QUESTION:

When using a wet vent system for back to back bathroom groups, do both lavatories require a dry vent connection?

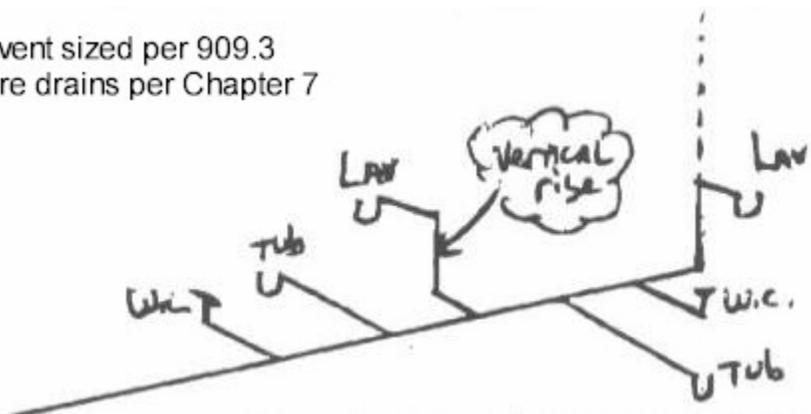
Wet vent sized per 909.3
Fixture drains per Chapter 7

In reference to a **Wet vent system** installed per OPC section 909.

If two lavatories are included in the wet vent system, do both of them need to be physically vented to be considered a proper wet vent? Or in other words, can one of the lavatories **not** be physically vented and still be considered a proper wet vented fixture in accordance with OPC section 909?

“By consensus, it is the opinion of this committee, that this installation would not be considered a proper wet vent. If sized per chapter 7 as noted on the drawing, the down stream lav would have to be vented.”
